Central Planning Authority

Agenda for a meeting of the Central Planning Authority to be held on May 12, 2021 at **10:00am, in Conference Room 1038, 1st Floor, Government Administration Building, Elgin Avenue.**

CPA/10/21

Figure 1: LIS 2018 imagery showing historical turtle nests on the critical nesting beach as well as the primary vegetation located on the site. The green dots indicate historical green turtle nests and the orange dots indicate historical loggerhead turtle nests.

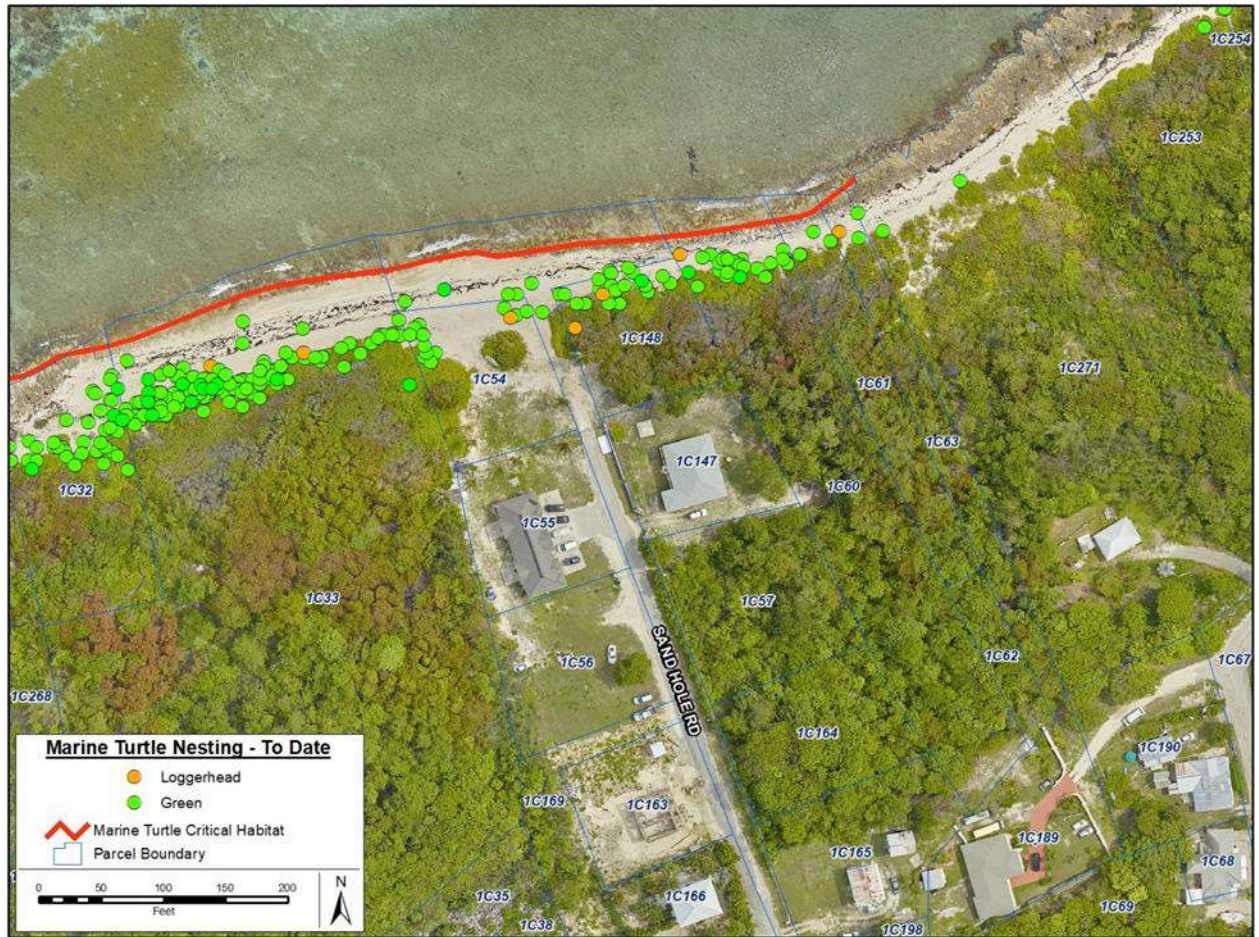
In accordance with section 41(5)(a) of the National Conservation Law, the Department directs the use of turtle friendly lighting on this development site. Figures 2-4 provide examples of other properties in Grand Cayman that have turtle friendly lighting installed.

The Department notes that the applicant's site plan refers to the entirety of the coastline as being ironshore and the proposed pool and pool deck are located 50 feet from the High Water Mark. Hard structures on the sandy area of the nesting beach decrease the size of the potential turtle nesting habitat. As this is extremely important turtle nesting habitat, a 75-foot setback would be more appropriate for this area. Increased setbacks will not only give critically endangered turtle nesting populations more room to nest but can also benefit the applicant. Increasing the coastal setback increases the resilience of properties against the inevitable effects of climate change such as coastal flooding, storm surge and erosion by ensuring that hard structures are located in a way that reduces their susceptibility to these hazards. An increased setback also allows the applicant to retain more sand reserves which aid in the beach's potential to recover after major storm events.

1. A revised plan shall be submitted showing all hard structures including the pool, pool deck and any other ancillary features setback a minimum of 75 feet from the High-Water Mark.

2. A vegetated buffer with a minimum width of **at least 10 feet** shall be maintained (and planted where necessary) along the 75-foot coastal setback boundary of the application site. Additional planting within the buffer shall comprise appropriate native coastal vegetation. There shall be no hard structures seaward of the buffer. The under-brushing and access points through the vegetated buffer shall be agreed with the DoE.

3. The applicant shall prepare and submit a turtle friendly lighting plan which minimizes the impacts of artificial lighting on sea turtles. The plan shall be reviewed and approved by the Department of Environment, in accordance with the DoE's Turtle Friendly Lighting: Technical Advice Note (September 2018) available from <http://doe.ky/marine/turtles/turtle-friendly-lighting/>.

Figure 3: An aerial image showing mangrove area loss on the western end of Grand Cayman since 1976 (Source: LIS 2018 and DOE 2018)

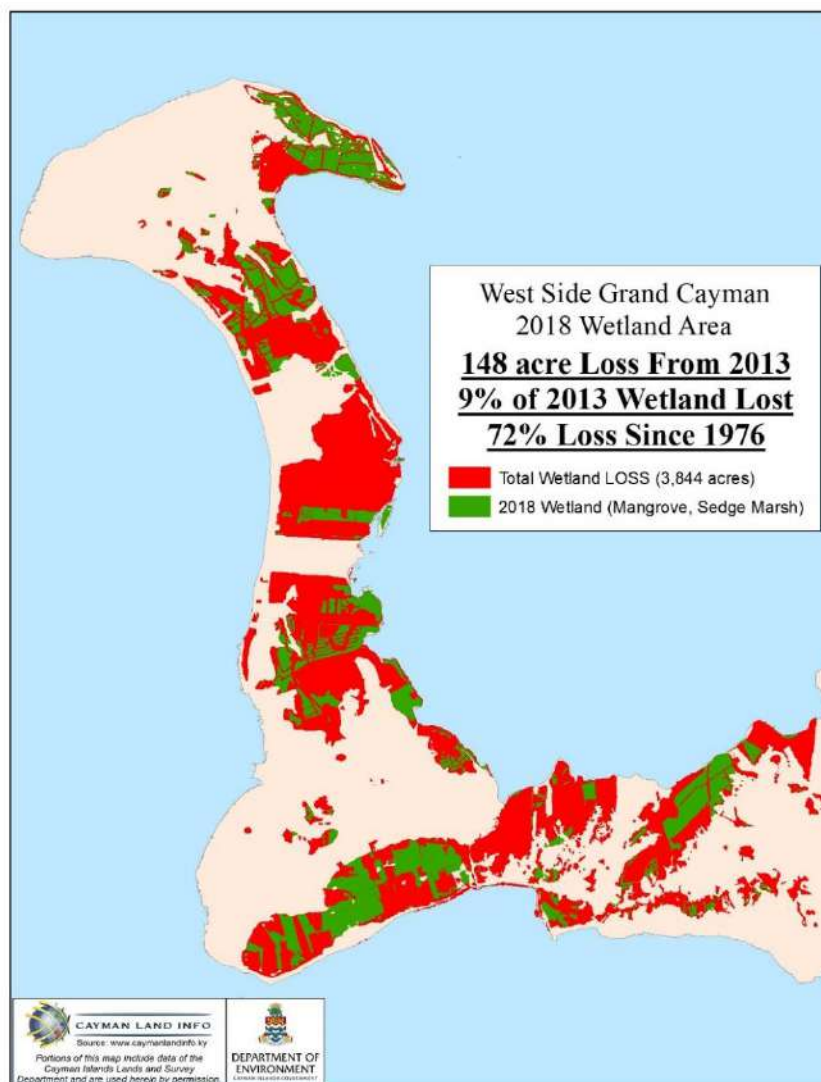
Although the proposal outlines that it will make 'use of existing water features' it includes no detail of measures to retain any of the existing mangroves or other vegetation into the landscaping and no specific details of the stormwater management plan have been included which may include the preservation of wetland areas in order to utilise their water storage capacities in water retention areas. The proposed lakes on the landscaping plan do not align with existing waterbodies on the site. In master planning this site the DoE is concerned that the appropriate consideration and integration of natural resources into the overall PAD has been neglected.

The applicant has indicated that the landscaping will use native plants where possible, which will offer some mitigation for the loss of native vegetation, but it will not deliver the ecosystem services that the mangrove habitat provided.

Figure 3: Plan Extract showing the proposed development (Source: Robert Towell Architect Ltd. Jan, 2021)

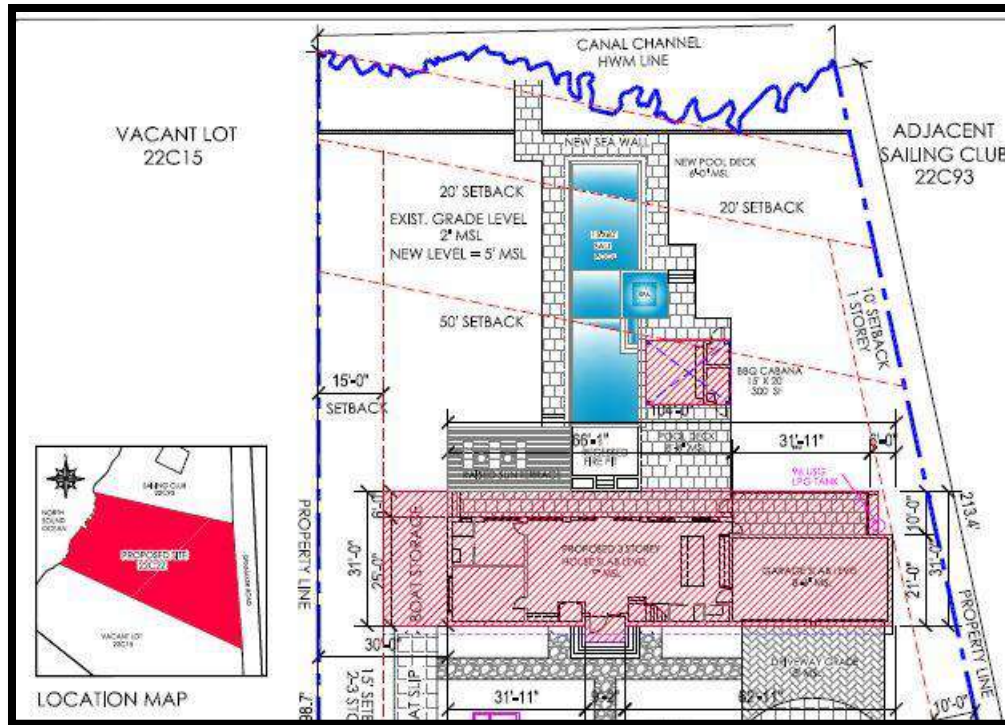
The application plans show the proposed swimming pool being constructed up to the water's edge, as shown in Figure 3.

The Department does not support the request for a setback variance and recommends that the plan is redesigned to take into account the minimum prescribed setbacks for a mangrove coastline (75ft from the MHWM). It is imperative that minimum coastal setbacks are met for all structures including seawalls, pools and pool decks, particularly given climate change predictions for the region and the increasing prevalence of coastal erosion associated with inappropriately sited development too close to the sea. Figure 3 shows that the shoreline is eroding with freshly exposed areas of rock and broken pieces seen in the sea. This highlights the importance of ensuring that setbacks are followed. In order to improve the stability of this shoreline, the applicant could plant red mangroves along the shoreline which will help to bind and stabilise the sediment along the coastline. The DoE can provide further guidance on mangrove replanting.

Figure 2: LIS 2018 Aerial image overlaid with site plan (Source: Roland and Bodden 23 Sept 2020)

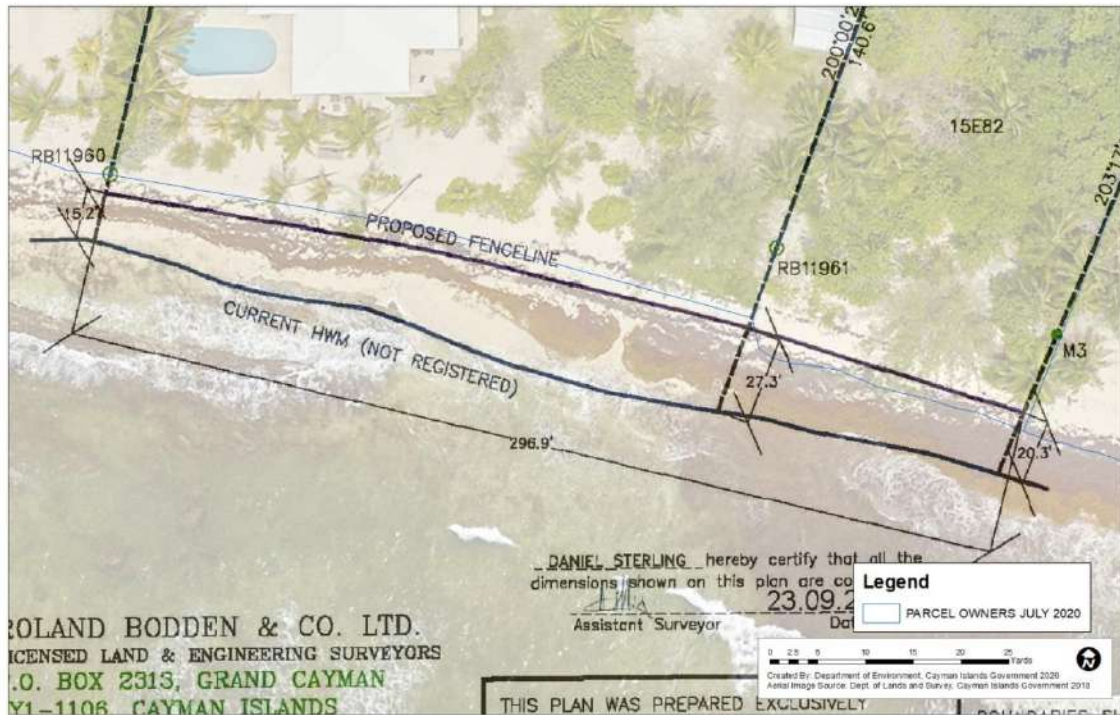
The site plan submitted (Drawing Ref: 15E238SiteMap.dwg) when overlaid onto the aerial imagery (see Figure 2) shows that the proposed fence line is positioned seaward of the current registered Mean High Water Mark survey, even though the most recent survey (which is not registered) as depicted by the site plan is seaward of the proposed fence line. This illustrates that the beach is extremely dynamic.

It is also important to highlight that survey posts were erected along the beach in June 2020 (see Figure 3) to show the proposed fence location, as confirmed by one of the owners. Once in receipt of this application, the Department undertook a site visit to determine if the survey posts were still in place and to observe the condition of the beach (see Figure 4, 5, 6 & 7). From the site visit, there were sections along the property where there had been significant erosion over the course of merely four months and many of the originally installed temporary fence posts were missing, presumed swept into the ocean. As anticipated it can be concluded from the site visits that the beach is highly dynamic and that the proposed fence is not an ideal location. Had the proposed fence been erected instead of the survey posts, the fence would have been damaged and sections lost due to recent inclement weather. The proposed fence is located within an area where the Mean High Water Mark constantly adjusts, and therefore may not always be on the applicant's property. If not damaged or destroyed, it may block public access along the foreshore during natural cycles of erosion.

- *The fence should be moved further landward behind the existing beachside vegetation and the registered Mean High Water Mark as shown in Figure 1 (the blue line). The existing vegetation represents the boundary of the most recent erosion cycles and consequently behind it the beach is most stable.*
